7.3 First Floor
Change From Consented Tracker & Comparative Sketches

18.11.20 Rev -
42 Bedford Square:

Schedule of Changes Post Consent - Level First							
Schedule to be read in conjunction with General Arrangement Drawings. The drawings are clouded in orange to show the changes from the consented drawings and in blue to show the changes submitted as part of LBC 2020/2253/L and are pending. They are also numbered in line with the schedule below for clarity.							
Ref No.	Room Number	Changes from consented LBC drawings	Drawing Reference	Description	Heritage Impact	Conservation Officer Verbal / Written Agreement SUBJECT TO LBC APPLICATION	Notes
01F	1.02 Massage Room	Change of use from study to treatment room	(15)AP123_MH (15)AS135 (15)AS136, (15)AS140	Change of use as per clients request	This will have a reduced impact as the intervention is less than what would be required for a treatment room.	Item not discussed with Conservation Officer as areas were in abeyance at time of site visit.	BDP drawings show electrical fittings and sockets to walls only, radiator joinery covers and in timber panelling.

7.4 Second Floor
Change From Consented Tracker & Comparative Sketches

PROJECT TITLE 42 BEDFORD SQUARE	
PROJECT NUMBER P2005698	
DRAWING TITLE FIRST FLOOR	SCALE @ A3 VARIES
DRAWING No. 201015_SK01_FF PLAN	DATE 14.05.2020
	REVISION -

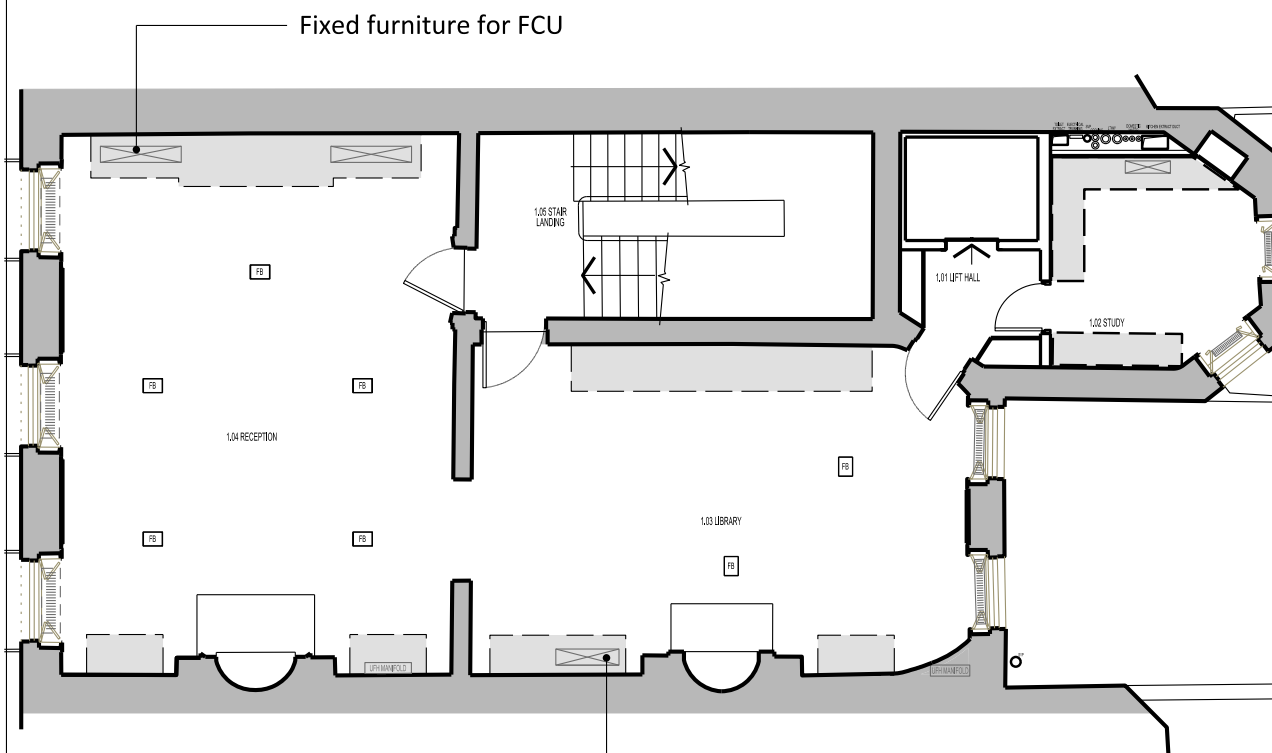
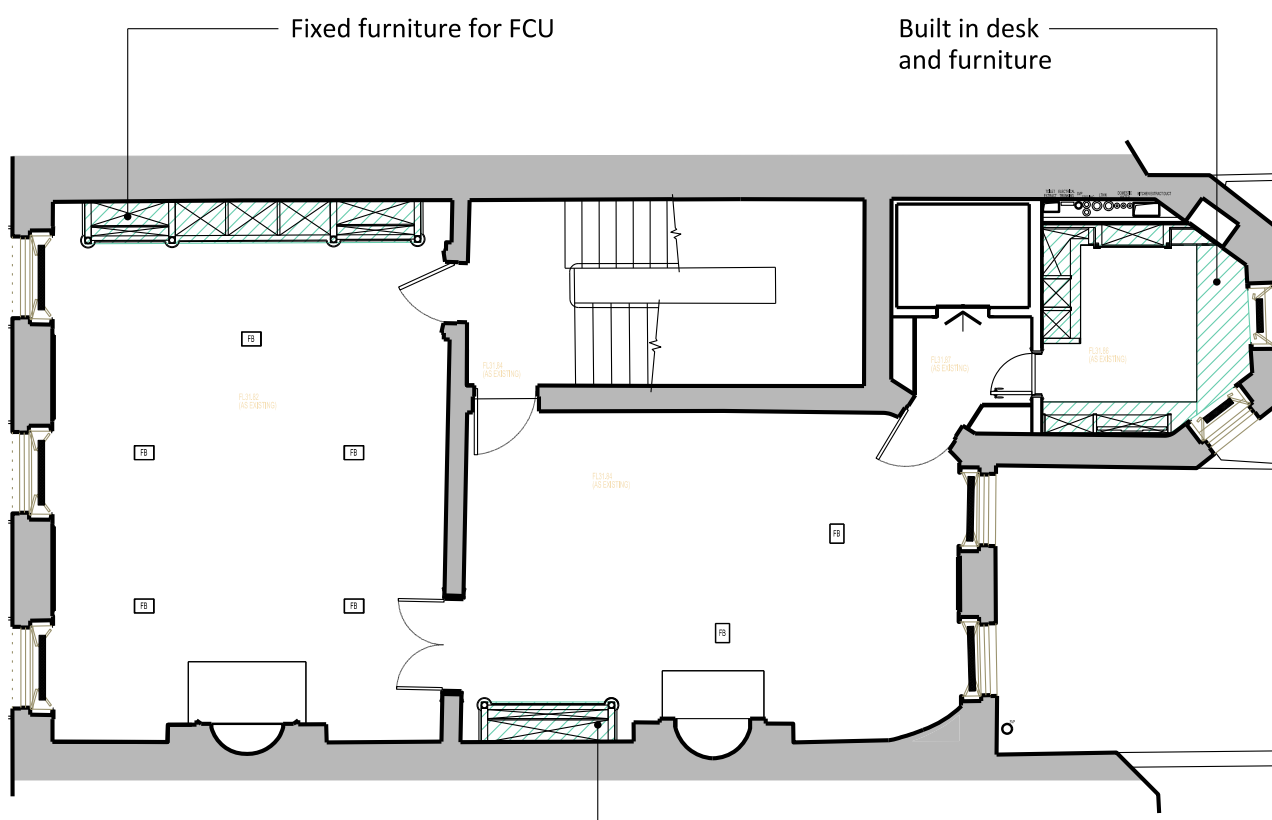
POST MEETING NOTE:
Additional Floor boxes are proposed
instead of wall mounted sockets.

DRAWING TITLE
FIRST FLOOR
ELEVATION 05

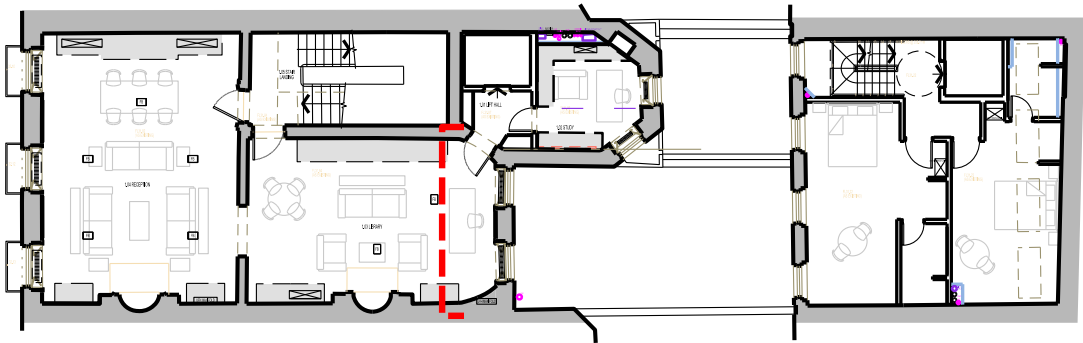
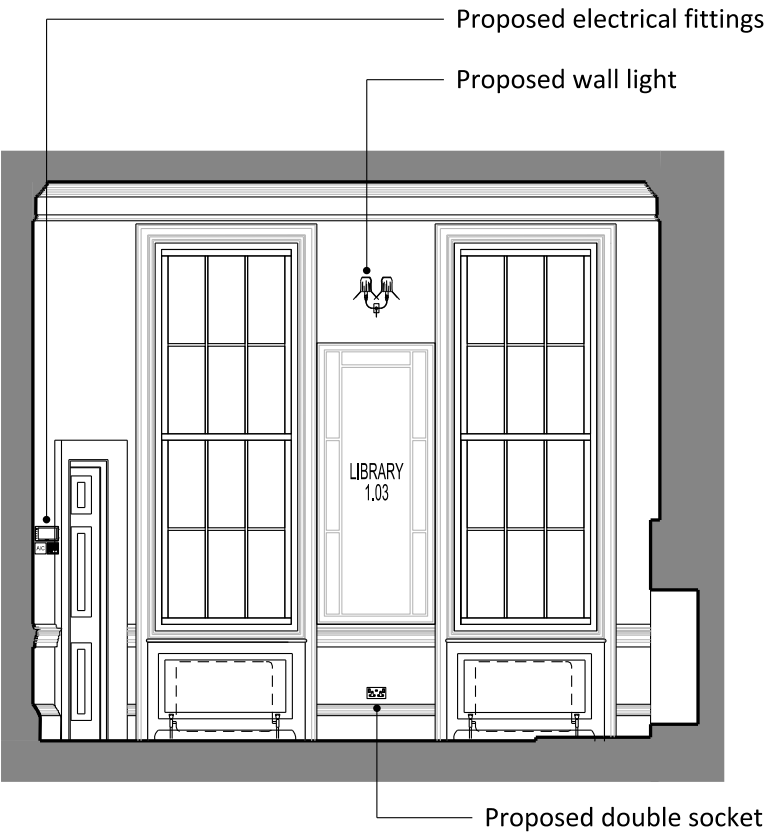
Floor boxes are proposed instead of wall mounted sockets. Electrical fittings reduced.

DRAWING TITLE
FIRST FLOOR
ELEVATION 03

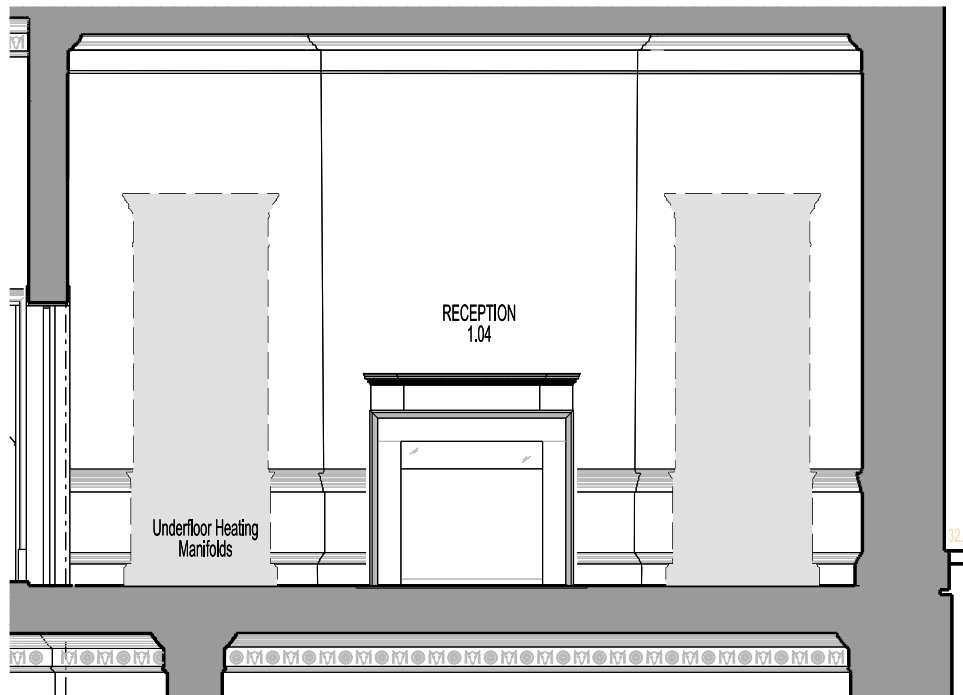
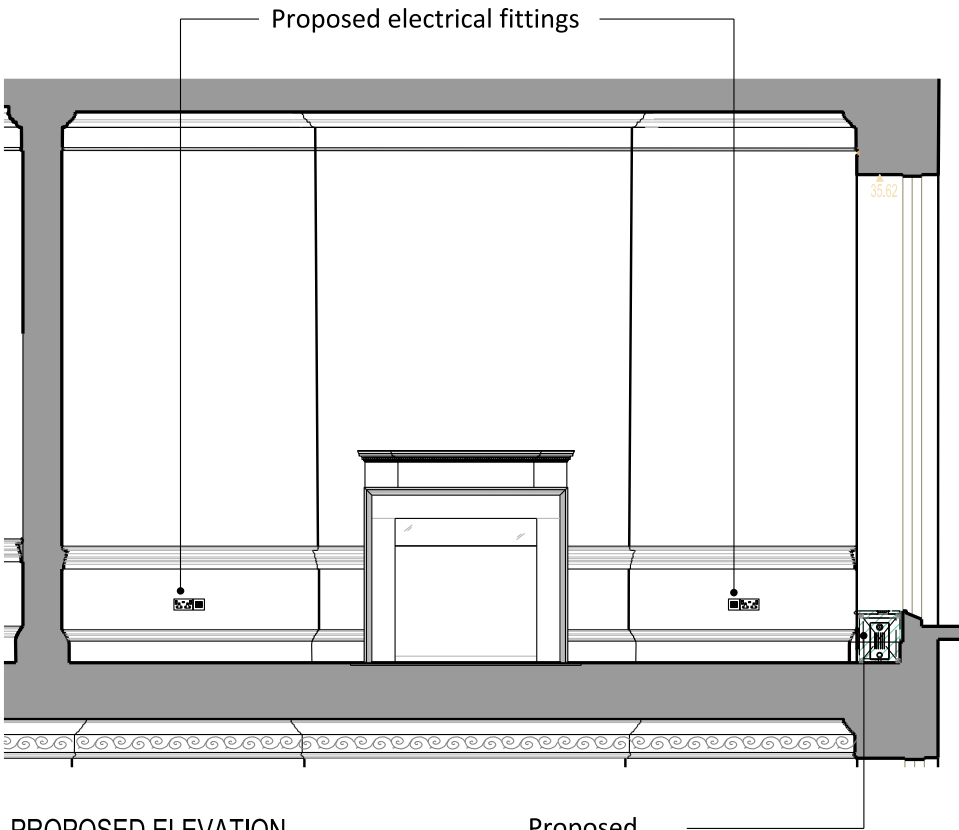
Proposed
joinery to
radiator

POST MEETING NOTE:
Floor boxes are proposed instead of wall mounted sockets.

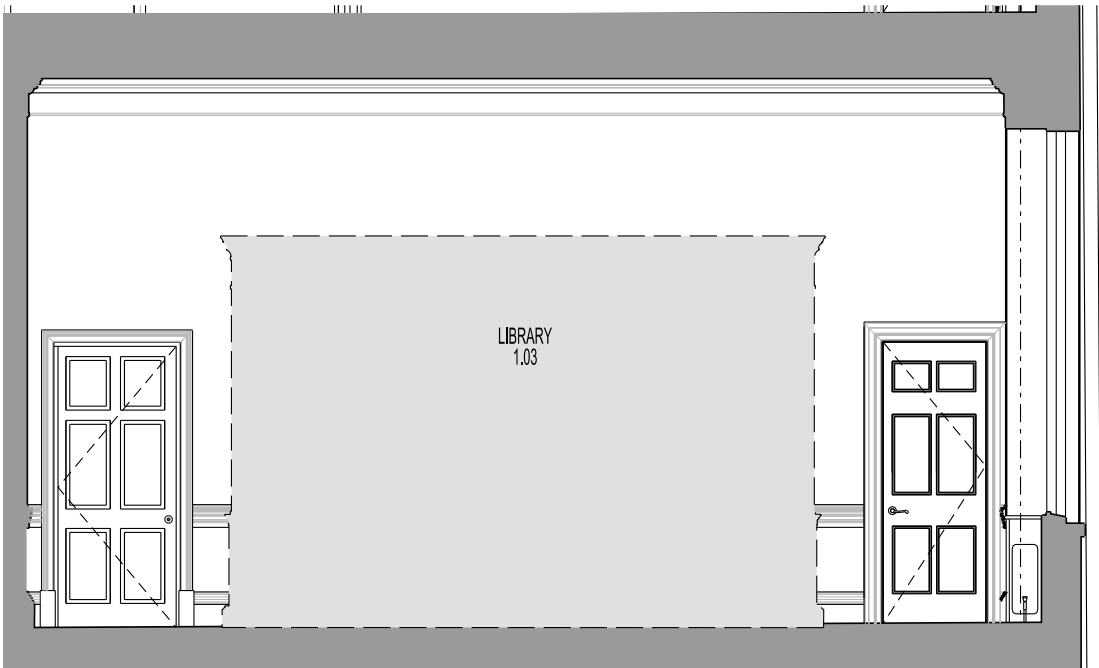
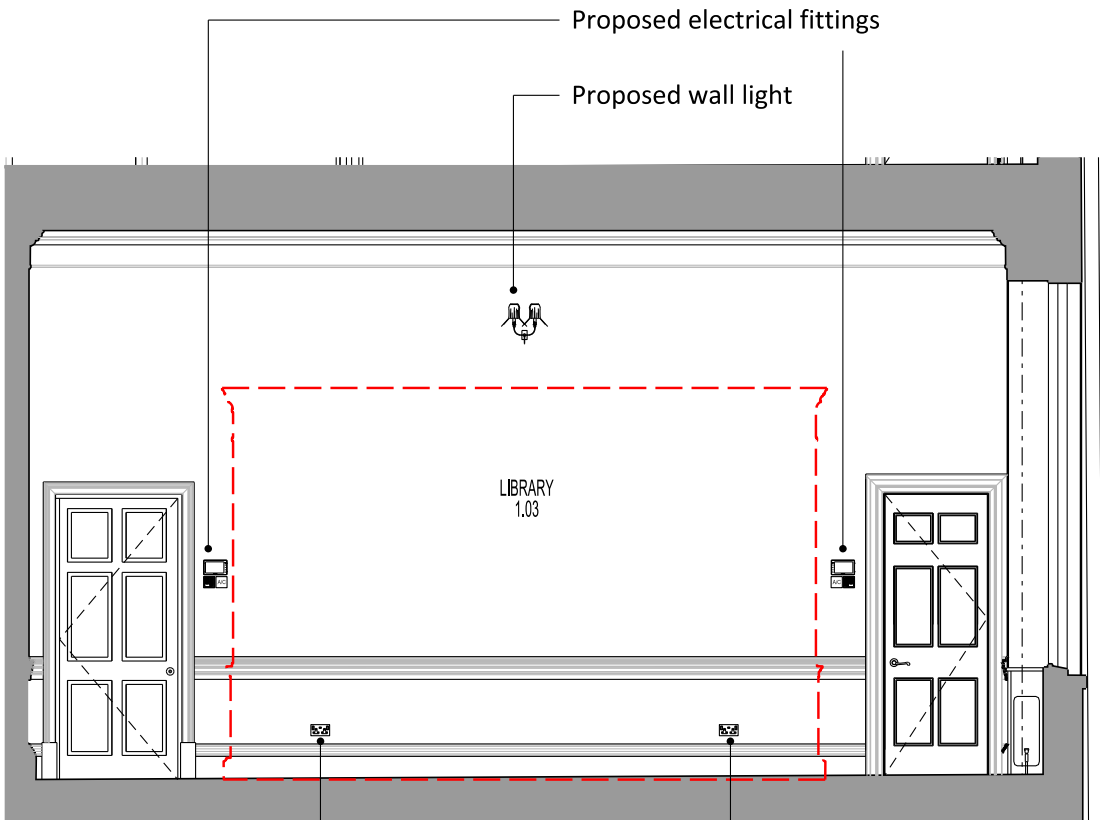
POST MEETING NOTE:
Floor boxes are proposed instead of wall mounted sockets.
Electrical fittings reduced.

DRAWING TITLE
**FIRST FLOOR
 ELEVATION 08**

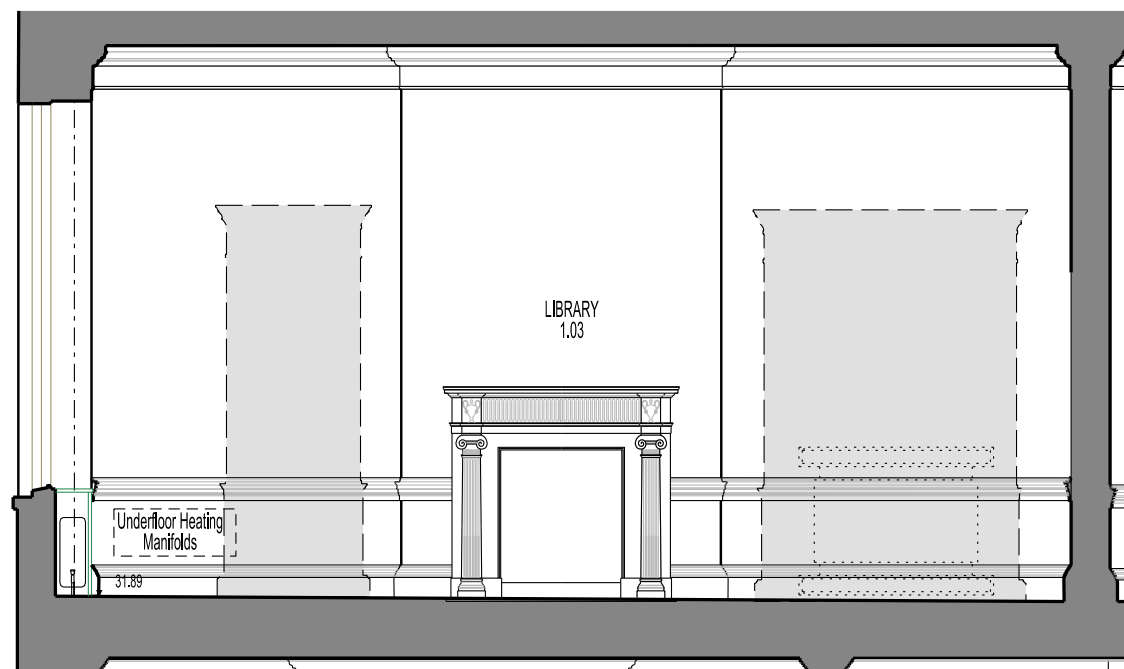
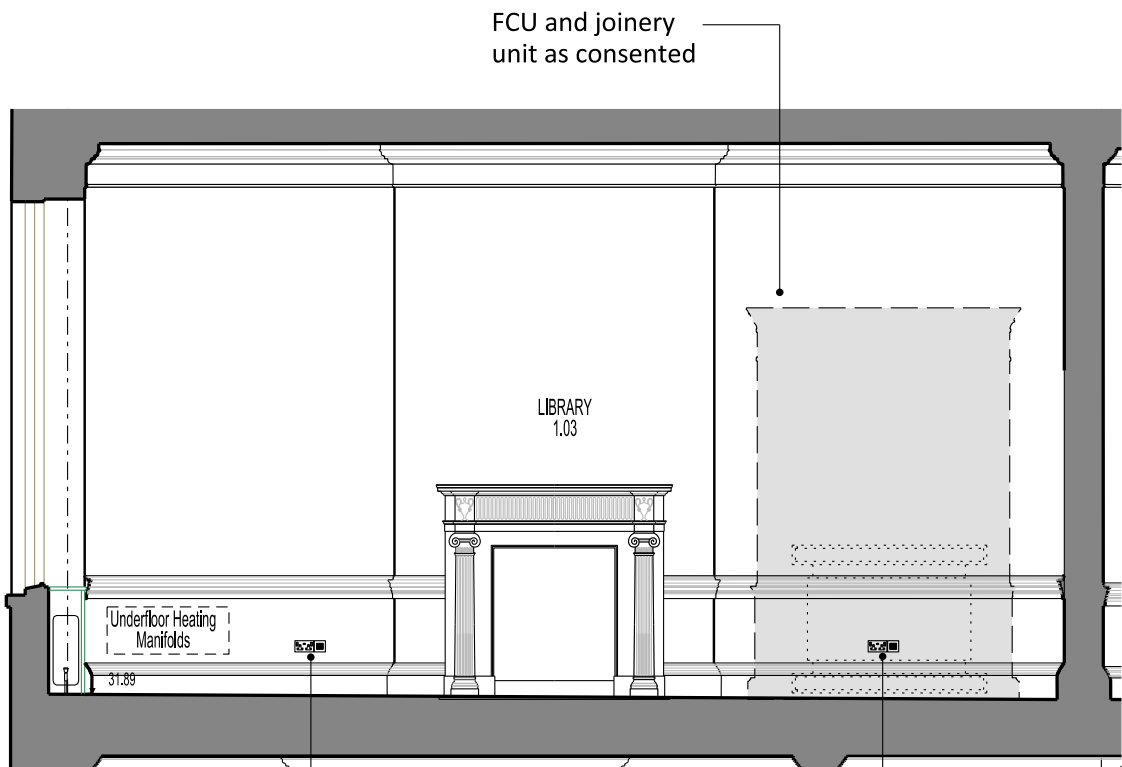
POST MEETING NOTE:
 Floor boxes are proposed instead of wall mounted sockets.

DRAWING TITLE
SECOND FLOOR
PROPOSED TEA STATION
CUPBOARD ELEVATION

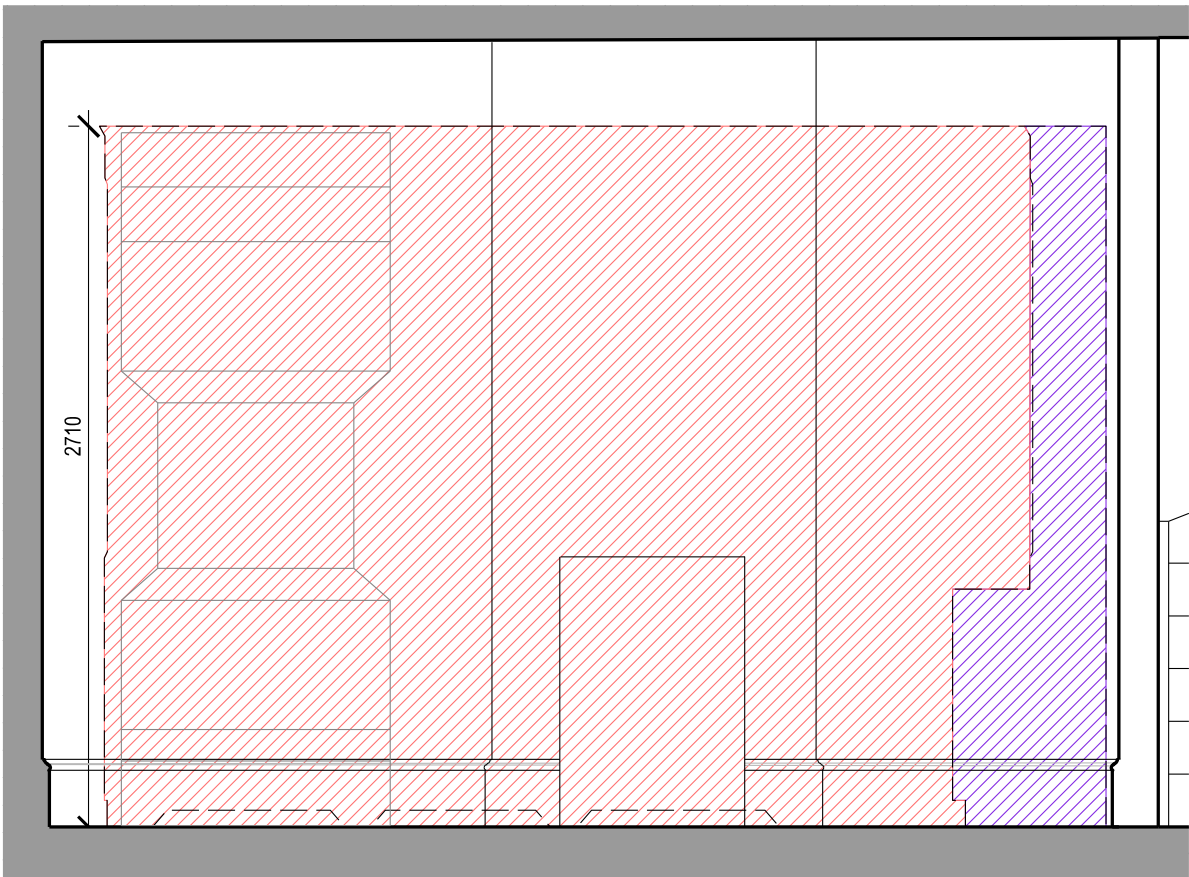
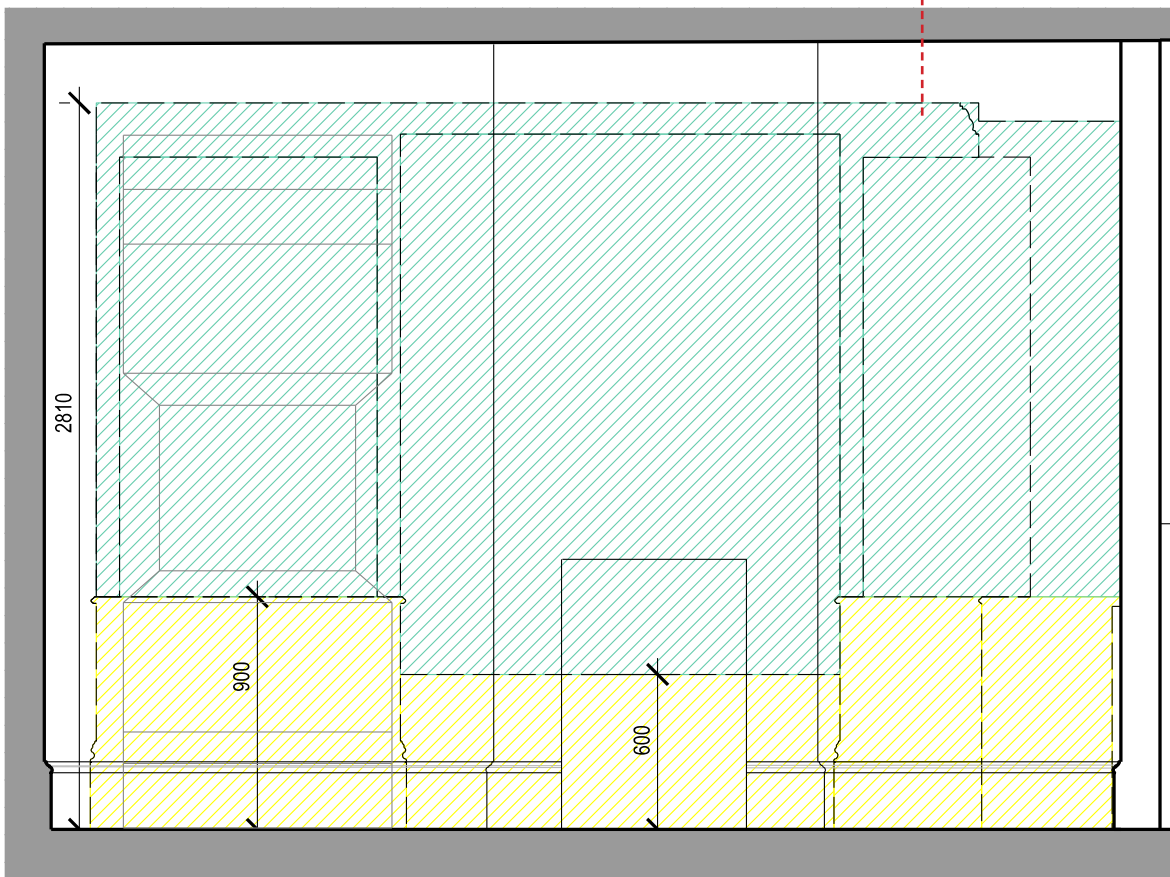
POST MEETING NOTE:
FCU relocated here
